Town of Rolesville, NC
Department of Planning

Comments on #SDP-26-0008 - Planning & Zoning: Site Development Plan

Application Number: #SDP-26-0008
Application Type: Site Development Plan
Date: September 11, 2026
Address: 408 E YOUNG ST, ROLESVILLE, NC 27571
Parcel: 1768098727

CID-25-07 | ROLESVILLE PLAN CASE # SDP-26-0008

SHEET NUMBER:
C-2.01

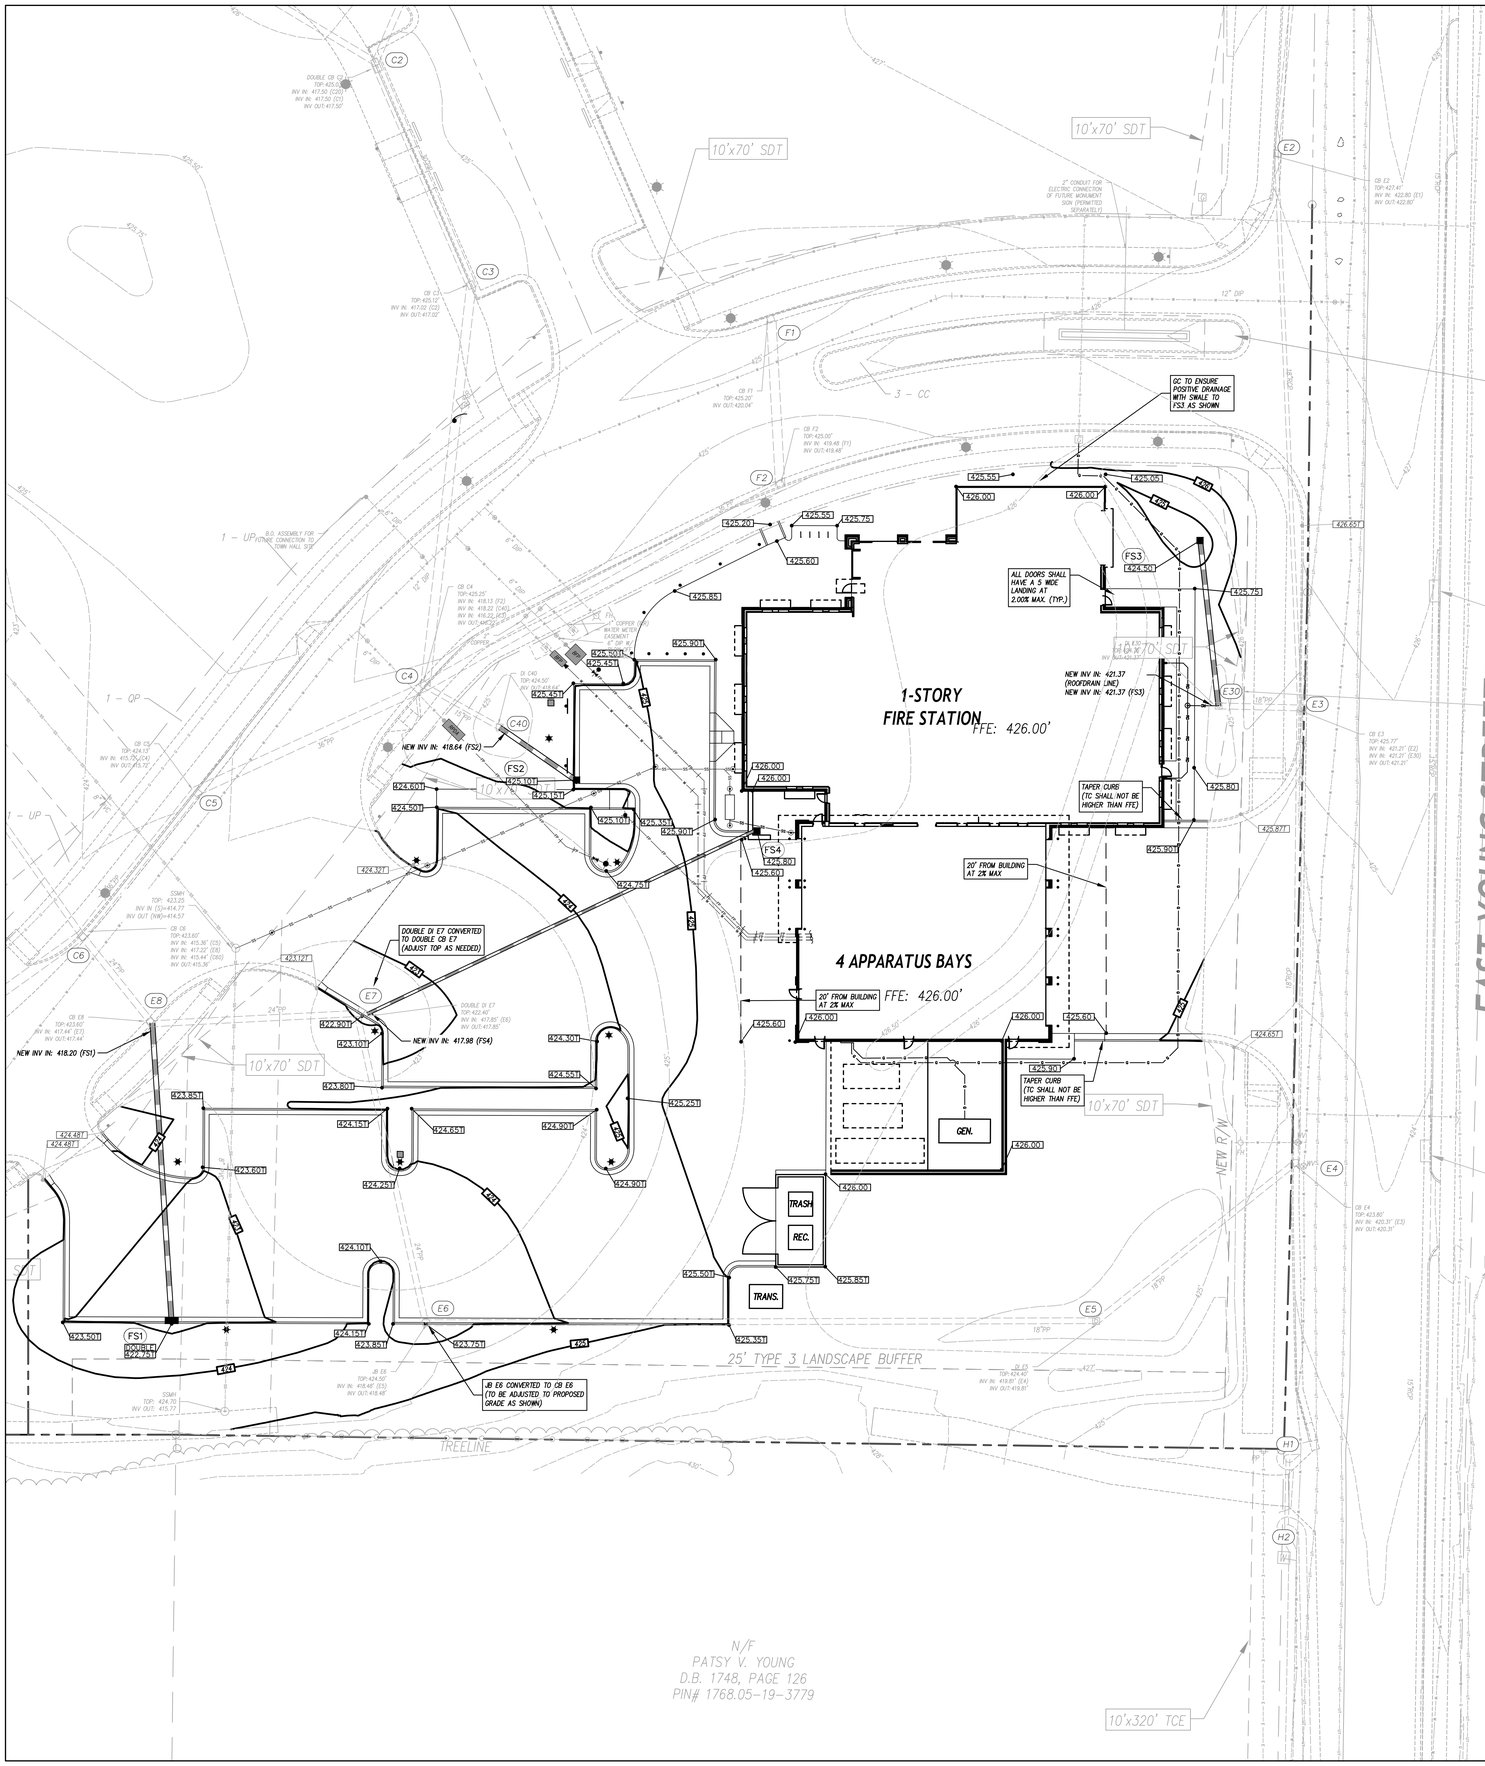
7 Jacqueline Thompson
It appears there are culverts here - clarify if these will be removed since they are under the roadway

10 Jacqueline Thompson
Adjust text for overlap - this comment applies to all relevant sheets.

11 Jacqueline Thompson
Please label and define what is being removed for the demo plan - all buildings show as existing but doesn't clarify demo

12 Jacqueline Thompson
REPEAT: Please include zoning of adjacent properties

AR200

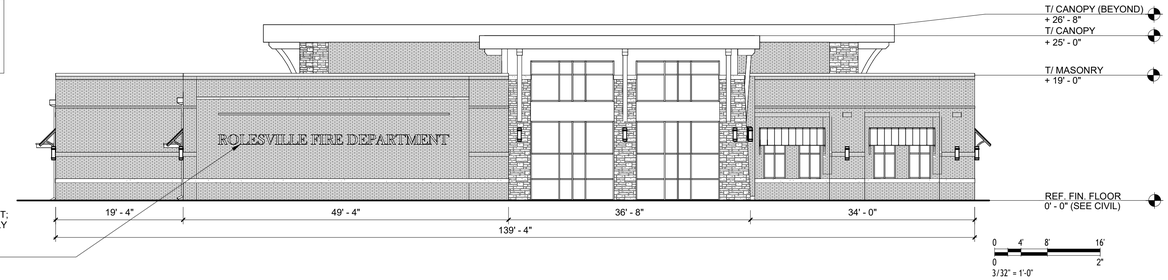
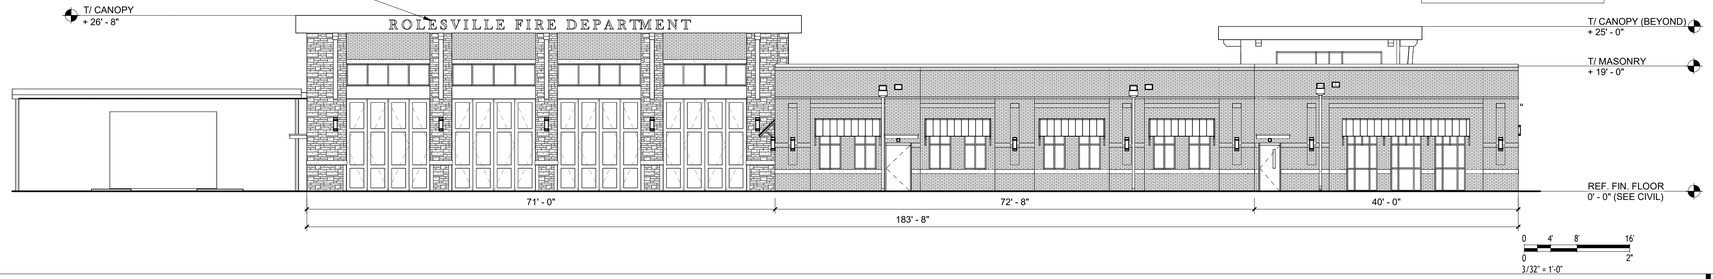
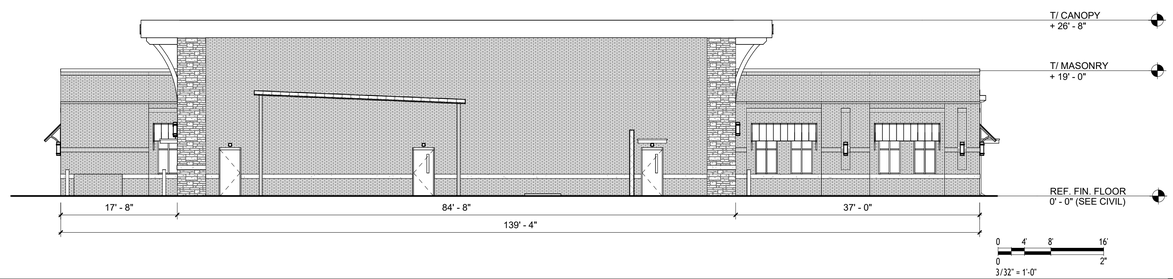
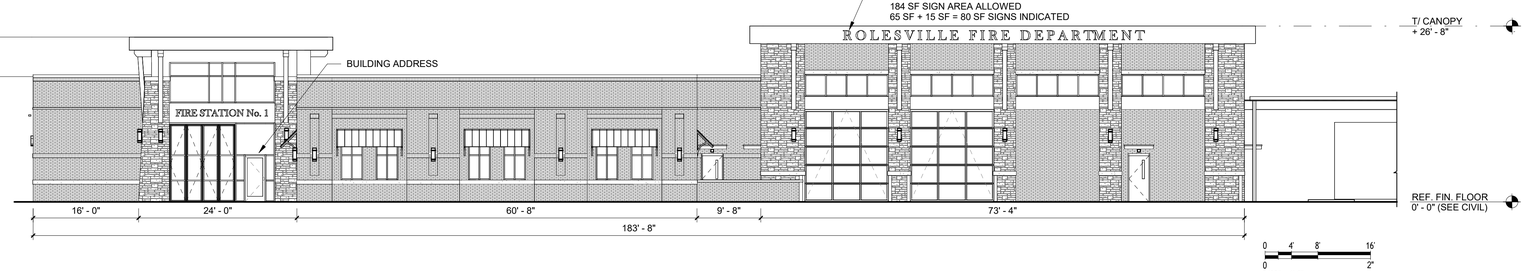
14 Stephen Wensman
Sheet AR200 includes a note stating 'WE REQUEST A VARIANCE TO GLAZING REQUIREMENT.' Variances to the Land Development Ordinance cannot be granted through a Site Development Plan review. If you wish to pursue a variance, you must submit a separate Zoning Variance Application to be reviewed by the Board of Adjustment.

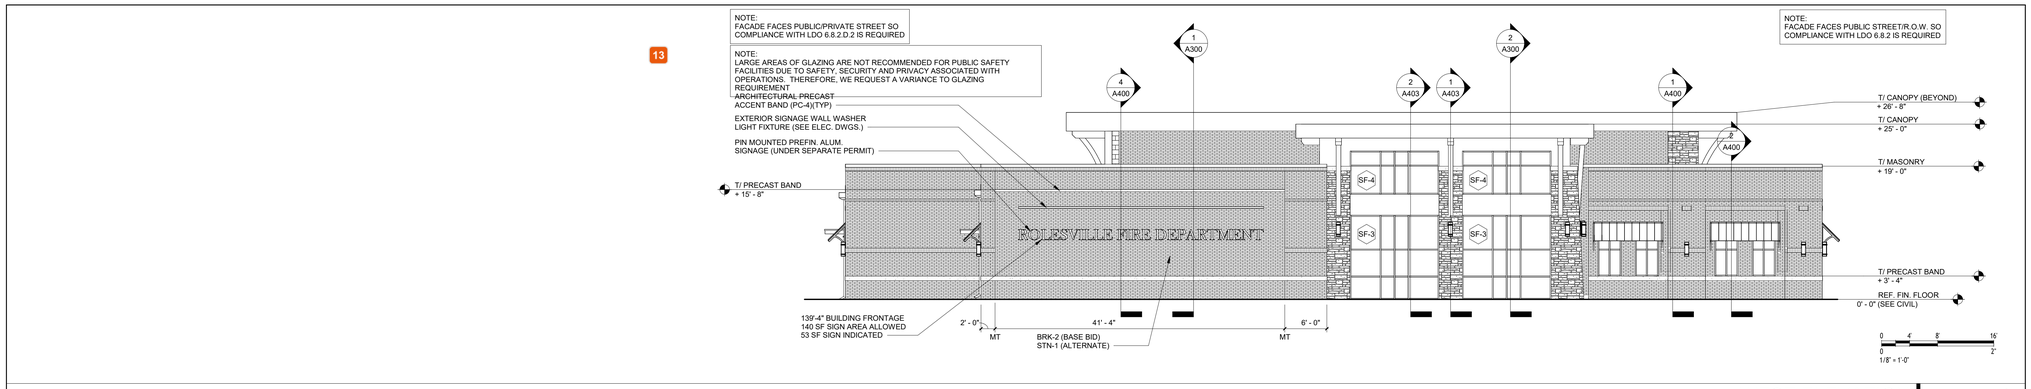
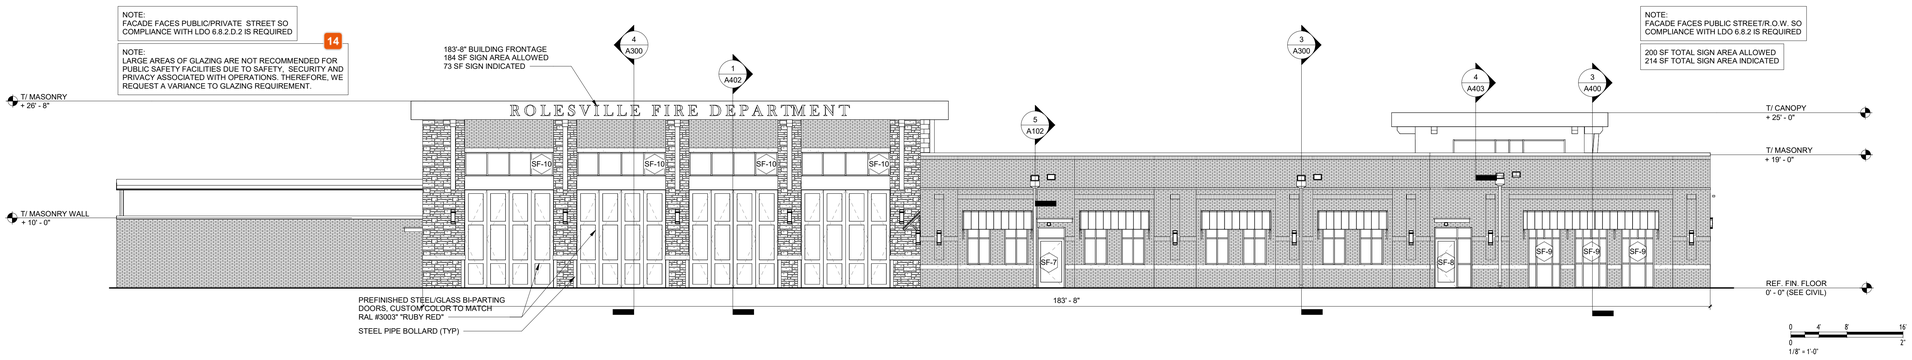
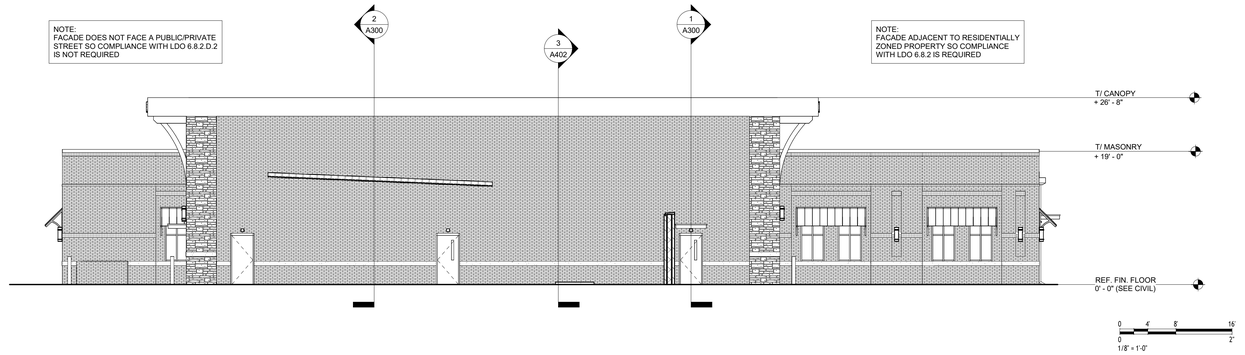
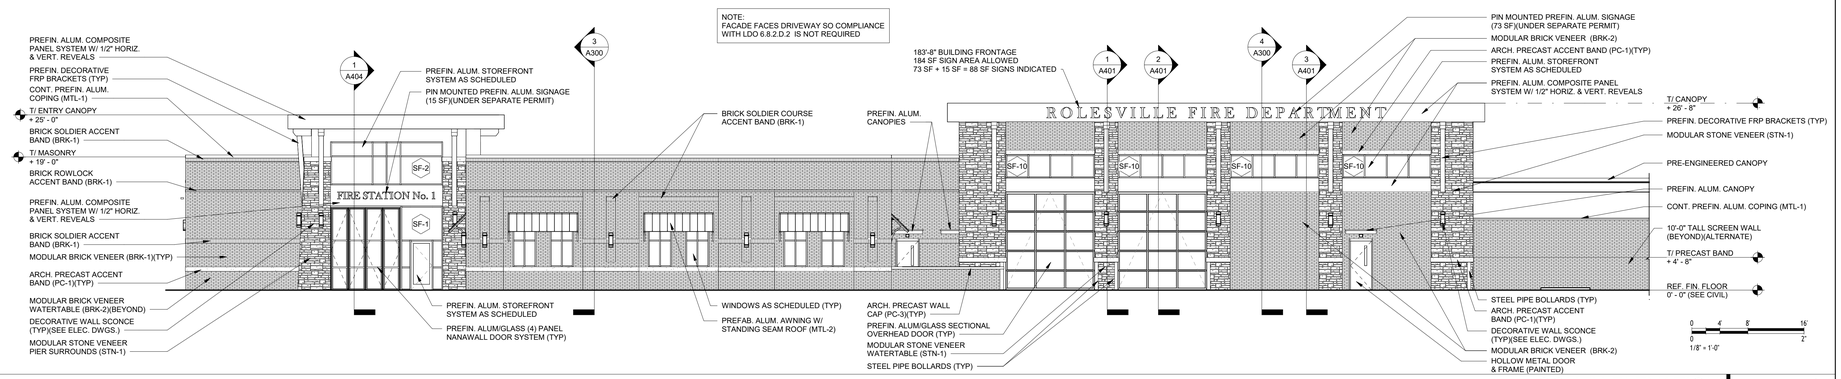
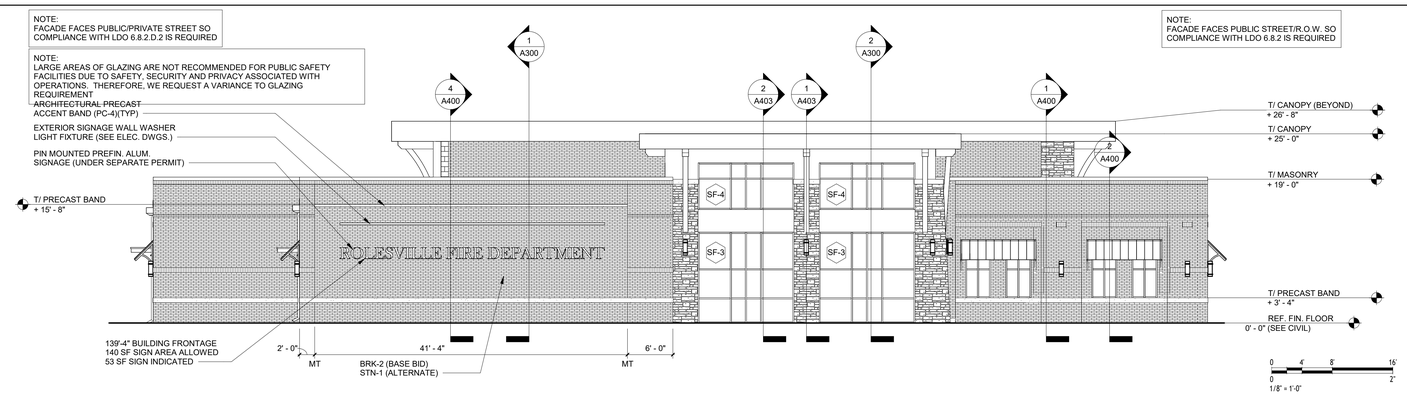
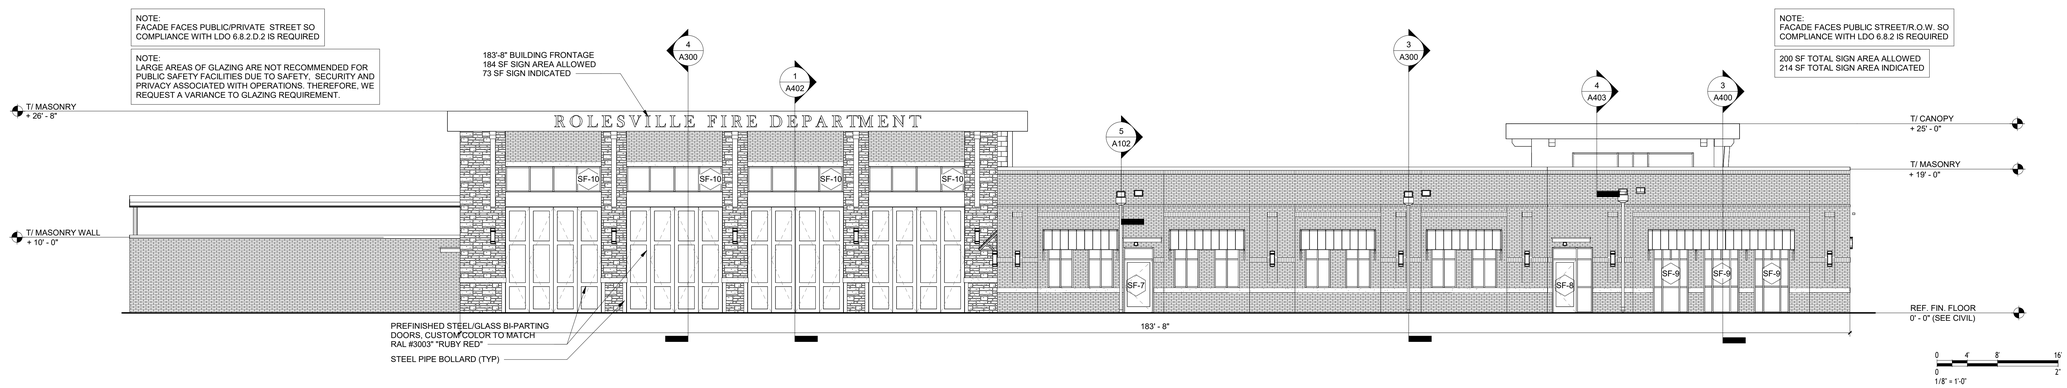
13 Stephen Wensman
The exterior elevations provided in the main Site Development Plan set (Sheet A200) differ from the separately uploaded elevations file (Sheet AR200). The separate AR200 sheet includes additional notes regarding LDO compliance and a variance request that are missing from the main plan set. Please ensure all submitted plan sheets are consistent and represent the most current version of the project.
